NO.	REVISIONS	DATE	BY
05	ADDENDUM 1 - THERMISTOR RELAY	2019-08-22	C.J.R.
04	ISSUED FOR CONSTRUCTION	2019-08-01	C.J.R.
3	REVISED TO ASBUILT	2017-11-01	K.R.
2	ISSUED FOR TENDER	2012-11-01	D.K.G.
1	ISSUED FOR 60% REVIEW	2012-07-25	D.K.G.

**NORTH END WATER POLLUTION CONTROL CENTRE**  
REHABILITATION OF DIGESTER No. 11, SLUDGE HOLDING TANKS No. 5 AND No. 7

DIGESTER NO. 11 MIXING PUMPS P&ID

BID OPPORTUNITY NO. 630-2019  
CITY DRAWING NUMBER 1-0101D-A0082-001  
SHEET 16 OF 44

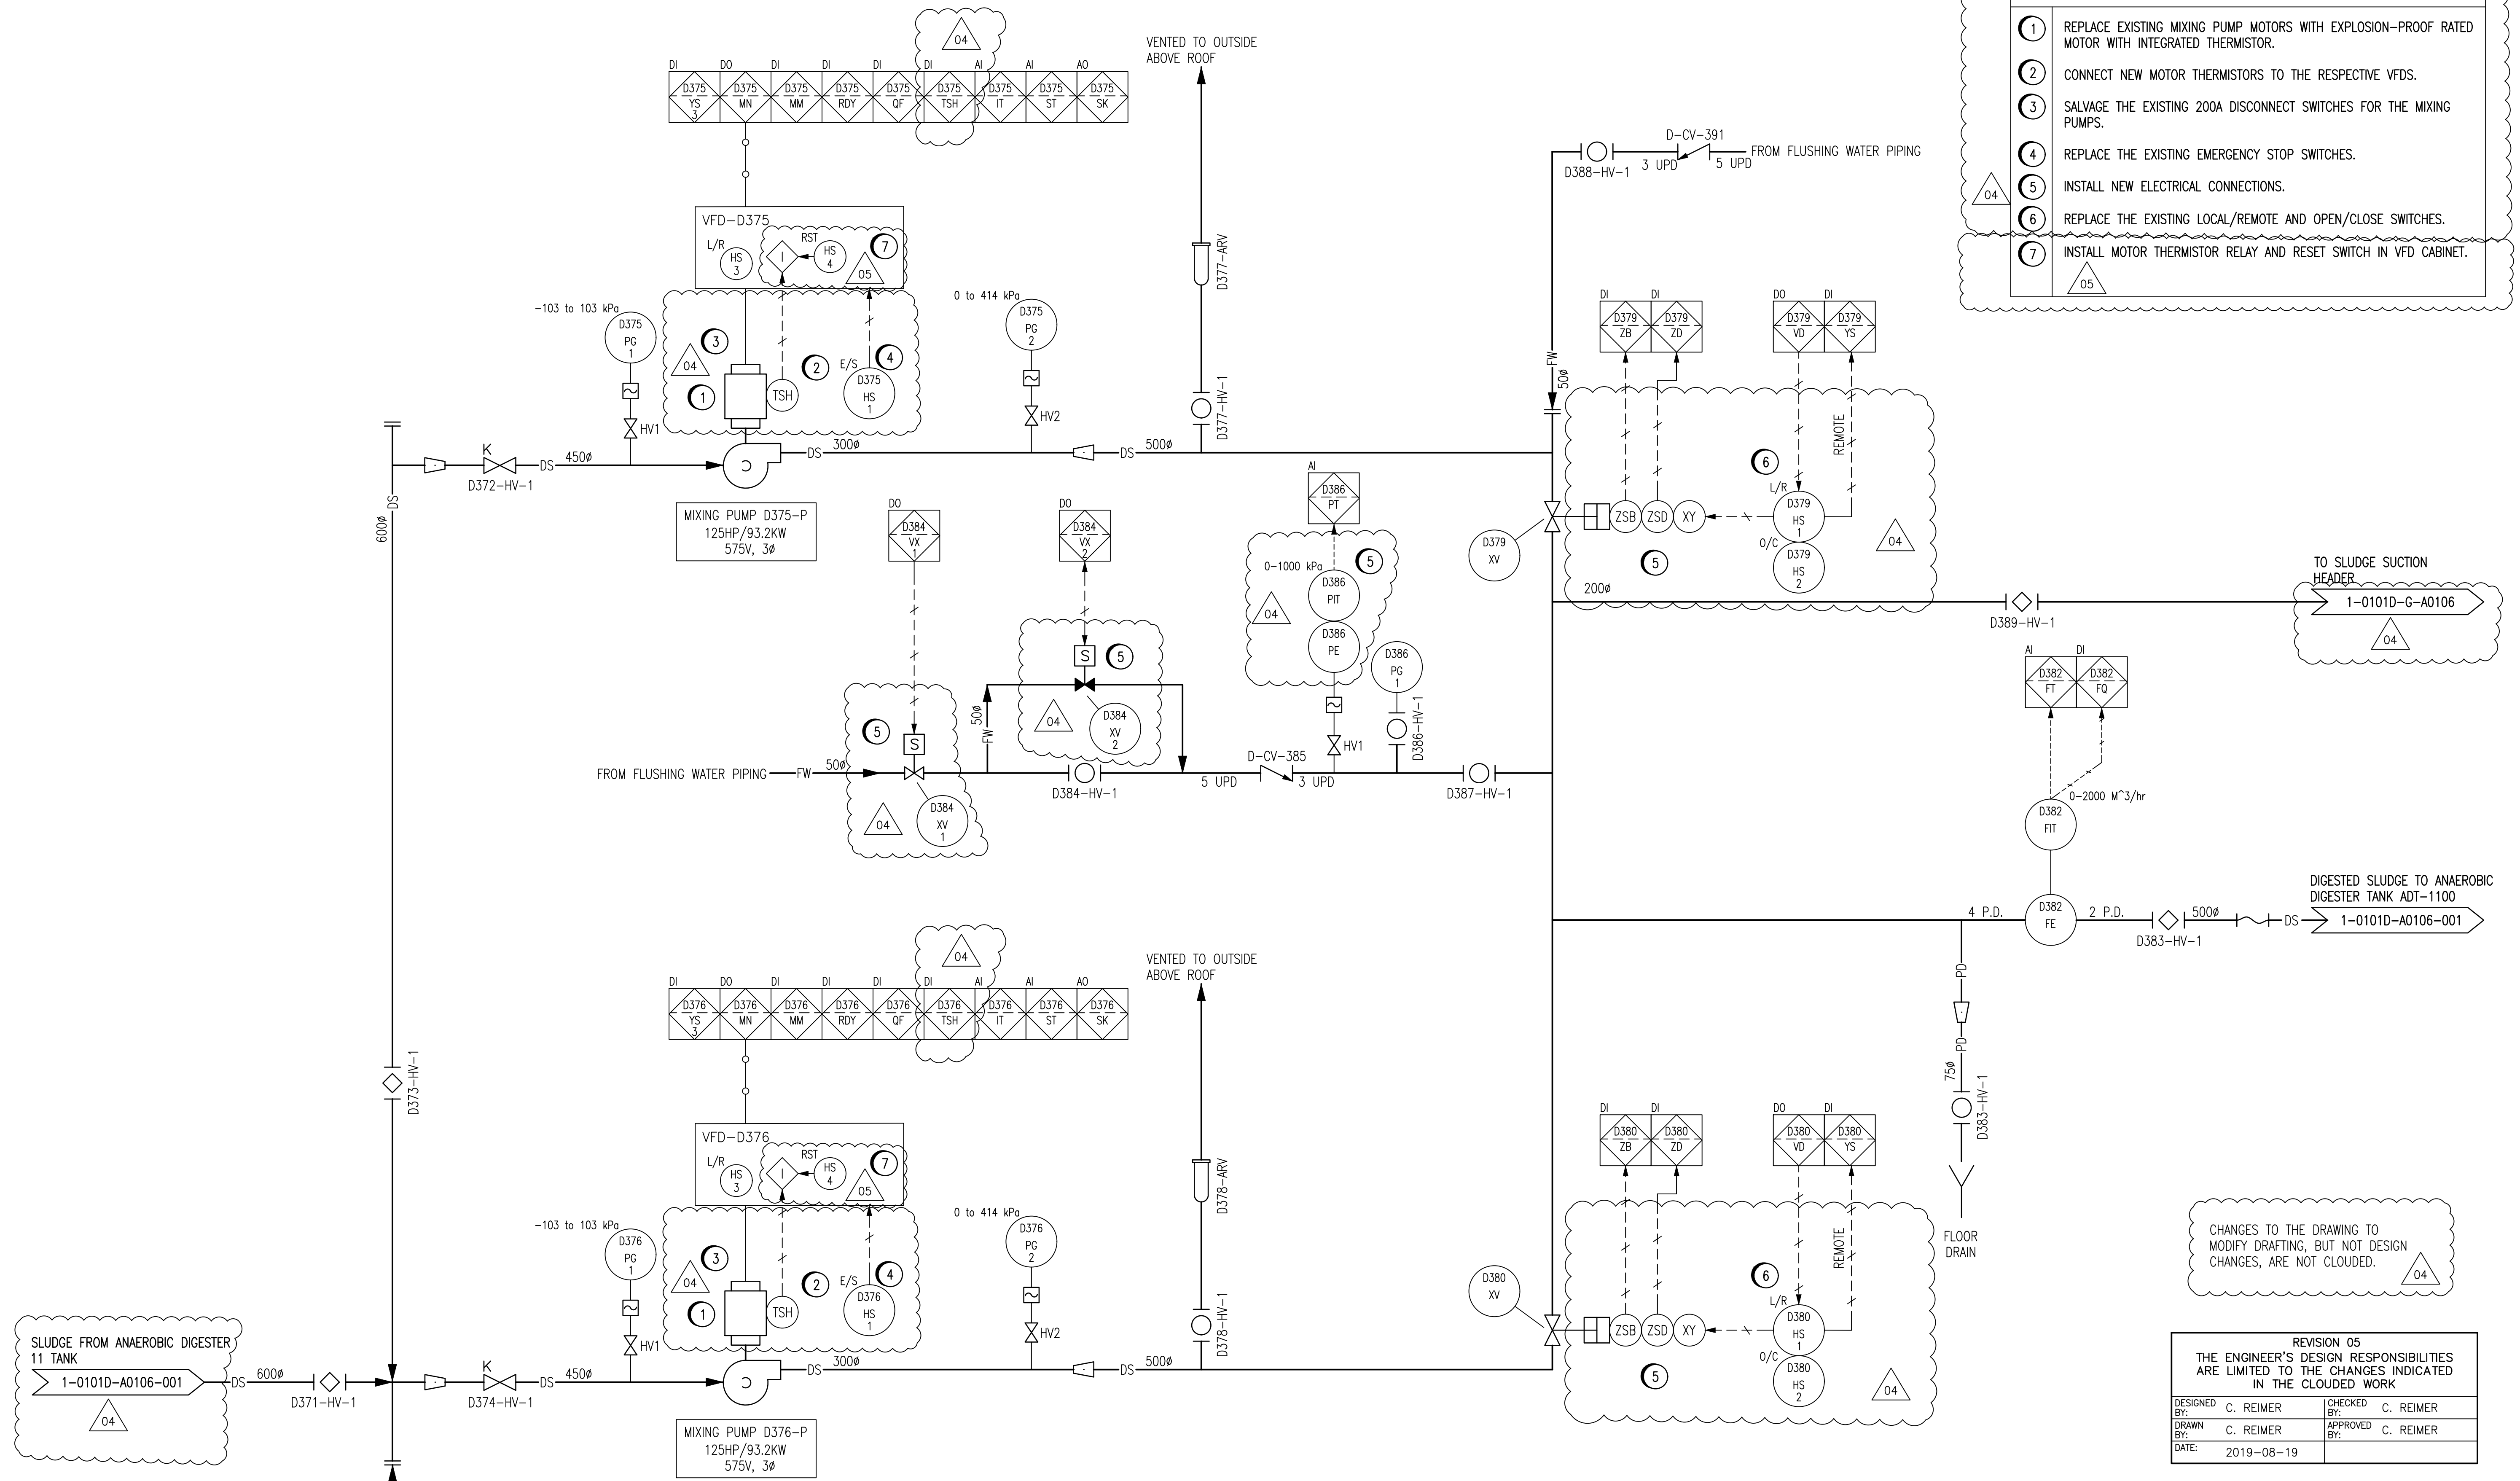
- 1 REPLACE EXISTING MIXING PUMP MOTORS WITH EXPLOSION-PROOF RATED MOTOR WITH INTEGRATED THERMISTOR.
- 2 CONNECT NEW MOTOR THERMISTORS TO THE RESPECTIVE VFDs.
- 3 SALVAGE THE EXISTING 200A DISCONNECT SWITCHES FOR THE MIXING PUMPS.
- 4 REPLACE THE EXISTING EMERGENCY STOP SWITCHES.
- 5 INSTALL NEW ELECTRICAL CONNECTIONS.
- 6 REPLACE THE EXISTING LOCAL/REMOTE AND OPEN/CLOSE SWITCHES.
- 7 INSTALL MOTOR THERMISTOR RELAY AND RESET SWITCH IN VFD CABINET.
